**CONCEPT EVALUATIONS
And
COMMENTS RECEIVED**

**LINWOOD/EASTERN AVENUE
INTERCHANGE FOCUS AREA**

Eastern Corridor Segments II and III

Concepts F7, F8 and F9

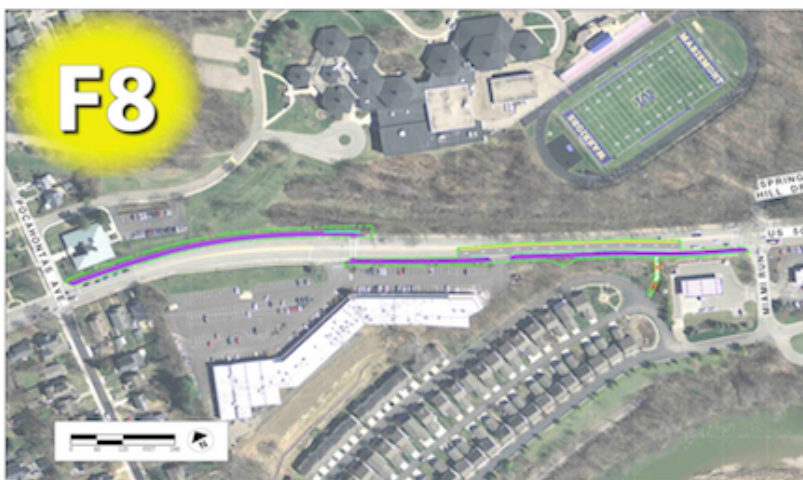
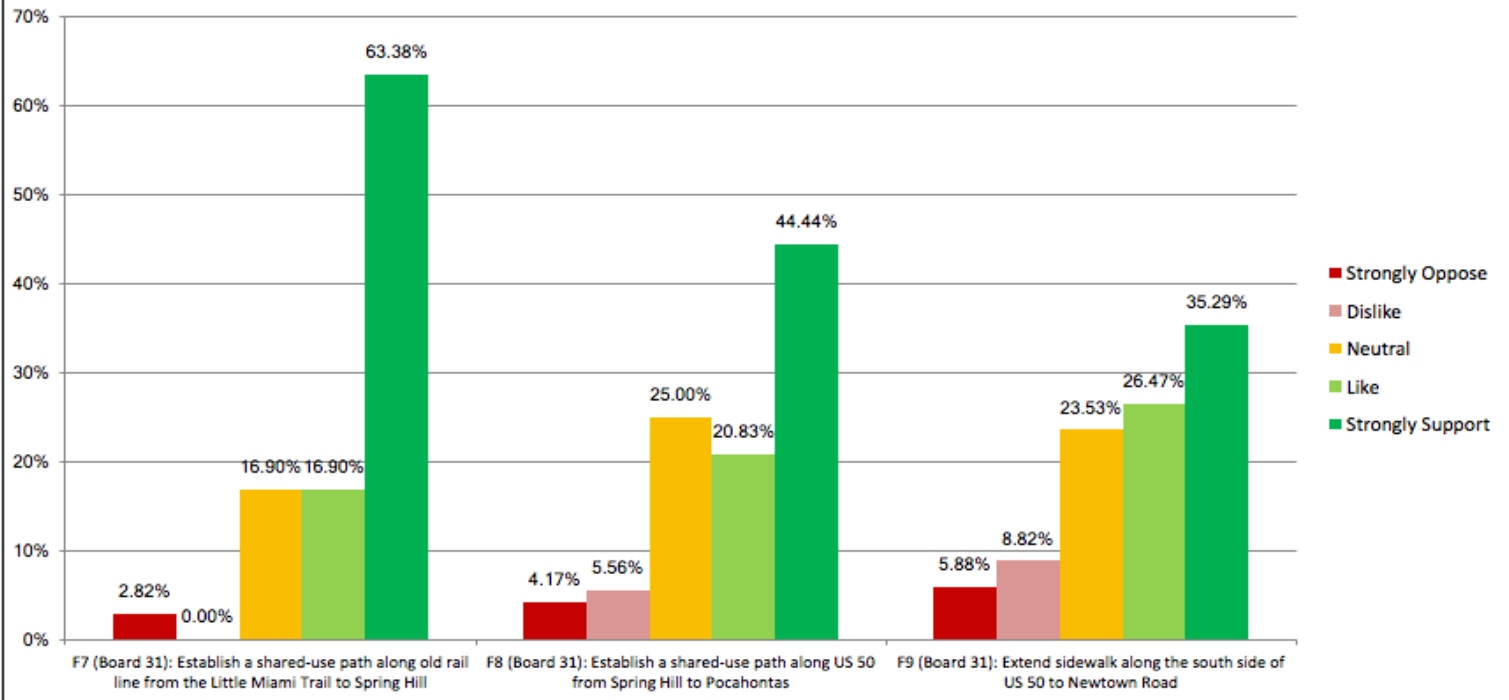
NO.	COMMENT	RESPONSE
1	Note: Mariemont has just passed a levy to fund construction of a new high school. Plans for the new high school involve creating a second exit via the Spring Hill Drive traffic light for Terrace Park-bound students. This should be taken into account by ODOT with respect to build option #F8. Perhaps the new route through the High School property to the Hamilton County Library might be considered as an alternative to the current route for build option #F8 to connect with build option #F7.	Thank you for your comment; we appreciate the additional information you have shared. Your input will be taken into consideration as we develop our recommendations.

NO.	COMMENT	RESPONSE
2	F7 - Great connections through the whole city to Little Miami trail by executing this!	Thank you for your comment. Your input is appreciated and will be taken into consideration as we evaluate the options and develop our recommendations.
3	F7 - I do not like the shared use path section between McDonalds and Kroger Fuel- crazy traffic. Could it access Wooster at Walton Creek (come from river behind Flipdaddy's on rest of little creek, then along Wooster and cross at way between H.S. and library, heading east cross Spring Hill and stay behind Snooty and Walgreens to Walton Creek?	<p>Thank you for your comment. Your suggestion is appreciated and will be taken into consideration as we evaluate the options and develop our recommendations.</p> <p>A study of possible alignments in this area was conducted by Great Parks of Hamilton County & Columbia Township. They identified the proposed alignment along the old railroad bed and up to Spring Hill as the most feasible.</p> <p>As part of this study, ODOT looked at which side of US 50 the alignment should follow. The hillside on the north side would require substantial retaining walls, making the alignment too costly. If the alignment is behind Snooty Fox and Walgreens, it would impact that same hillside and would also require costly retaining walls.</p>

4	F7, 8, 9 - Trail needs to connect along Rembold to Murray to Murray Trail at Settle Street.	Thank you for your comment. Your input is appreciated. This connection lies within the Village of Mariemont and discussions and decisions about it are being addressed by the Village. The Eastern Corridor study did not develop any concepts at this location for that reason.
5	I don't think F8 is needed if F7 is going to be completed. F7 is way overdue as that climb up 50 is unsafe between bicyclists slowing down and bicyclists needing to use the sidewalk and then endangering pedestrians as a tradeoff.	Thank you for your comment. Your input is appreciated and will be taken into consideration as we evaluate the options and develop our recommendations.

NO.	COMMENT	RESPONSE
	considered as an alternative to the current route for build option #F8 to connect with build option #F7.	
2	F7, 8, 9 - Trail needs to connect along Rembold to Murray to Murray Trail at Settle Street.	Thank you for your comment. Your input is appreciated. This connection lies within the Village of Mariemont and discussions and decisions about it are being addressed by the Village. The Eastern Corridor study did not develop any concepts at this location for that reason.
3	F8 - A shared use path not only needs to be built from Spring Hill to Pocahontas, but then continued down the Murray Ave median to connect to the Fairfax trail. Too many bikers and walkers are forced near, and onto, US 50 to get from the Little Miami trail and through Mariemont.	Thank you for your comments. Your input is appreciated and will be taken into consideration as we evaluate the options and develop our recommendations.

4	F8 - Crossing Wooster is treacherous at that light at any time.	Thank you for your comment. Your input is appreciated and will be taken into consideration as we evaluate the options and develop our recommendations.
5	I don't think F8 is needed if F7 is going to be completed.	Thank you for your comment. Your input is appreciated and will be taken into consideration as we evaluate the options and develop our recommendations.
6	Supportive of option F8, except is highly unlikely that a shared use path that requires crossing Highway 50 will remove many cyclists off the road (they, including myself) are likely to stay on the road. A shared-use path (or separated bike lane) on this stretch is much needed, but splitting it on opposite sides of the road will reduce utility and is a mindless waste of funds.	<p>Thank you for your comments. Your input is appreciated and will be taken into consideration as we evaluate the options and develop our recommendations.</p> <p>Connecting the Mariemont library and high school to the spur from the Little Miami Trail will require crossing US 50 at some location. The proposed location was chosen to minimize impacts to property owners and to avoid more costly retaining walls in other areas. The crossing is proposed at an existing signalized intersection to provide a pedestrian signal for safer crossing.</p>

7	<p><i>Received via mail:</i></p> <p>I enjoyed and was impressed with your public planning chart proposals for ODOT road and cycle improvements in our area. You and your team have put together an impressive list of improvement projects clearly illustrated by your planning charts.</p> <p>My interest from our Spring Hill residence is the bicycle path proposed to connect the Great Parks bike path extensions terminus at <u>Miami Run</u> to <u>Pocahontas</u> along the south side of US 50 West (Wooster Pike). This ODOT extension would provide a safe</p>	Thank you for your comments. Your input is appreciated and will be taken into consideration as we evaluate the options and develop our recommendations.

NO.	COMMENT	RESPONSE
	<p>bike path into the Village of Mariemont for residents of Spring Hill and Williams Meadow as well as other cyclists using the bike path.</p> <p>I know you commented that you personally biked that section & the hill is a killer especially along that stretch of highway 50. A safe bike path link in that area would do much for cyclists' access to the Eastern part of the Village safely!</p> <p>Thanking in advance for ODOT's and your consideration.</p>
